Office Action Summary	Application No. 10/551,373	Applicant(s) MITANI ET AL.	
	Examiner ASHLEY KWON	Art Unit 4111

DETAILED ACTION

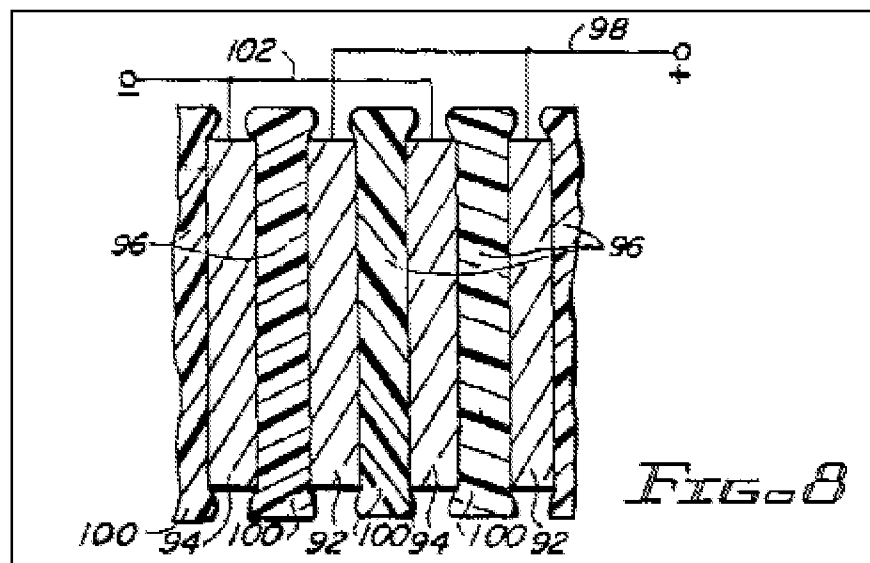
Regarding claim 1, Forte teaches a separator (96, see fig. 8) comprising a paper sheet (resilient fibrous mat, 20) mainly composed of glass fibers (see col. 7, lines 42-43) in which the fiber distribution is uniform in the longitudinal and the cross directions of the separator, and the fiber orientation is at random in the longitudinal and the cross

directions of the separator (see col. 13, lines 25-28). The resilient fibrous mat (20, see fig. 3) taught by Forte is uniform in density throughout its thickness and the fiber entanglement within the resilient fibrous mat is uniform throughout its thickness (see col. 6, lines 55-59). A separator with randomly oriented fibers (fiber entanglement) and uniform density would have a fiber distribution that is uniform and a fiber orientation that is random in the longitudinal and the cross directions of the separator.
